BALSHAM PARISH COUNCIL

Application by Kingsway Solar Farm Ltd – Scoping Consultation

Balsham Parish Council has read and reviewed Kingsway Solar's Environmental Impact Analysis Scoping Report and has had input from concerned residents.

Photo: from the Fleam Dyke towards West Wrattling showing the wind turbines on area B

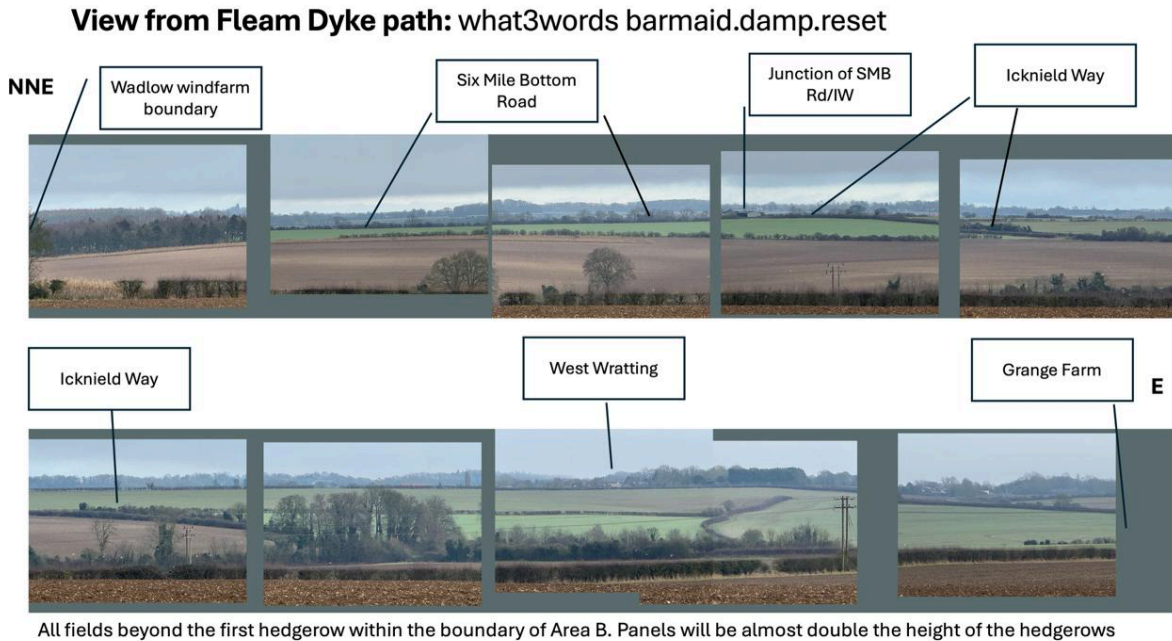
Section 6 describes the landscape as having rolling, gently undulating hills and clay woodlands with "long distance and open views" across the area. The elevated land in the middle of area B, with its 13 wind turbines, is visible from many miles away, particularly along the Fleam Dyke and Icknield Way footpath. Co-locating the solar farm in this area, as suggested in the plans, would make the new infrastructure highly visible.

Balsham residents frequently use the Fleam Dyke and Icknield Way (Fox Road) in Area B, as well as the Roman Road in Area A near Balsham. Both are popular routes for walking, cycling, and other recreational activities. They hold historical significance and local value, contributing to the area's character and providing an important connection to the surrounding landscape. The solar farm will have a significant impact on regular users of these routes.

This is a photo montage of a view of Area B from the Fleam Dyke path showing that screening of this area will be impossible.

The potential of a new construction road discussed in the ‘Traffic and Transport’ (Page 7) would run through the middle of this picture. Whatever Kingsway does to land area B, and the way they construct it, the impact on the village will be huge. The scoping EIA document does not reflect this or addresses the correct data analysis to assess it.

Action required: Detail any access roads and proposed routes.
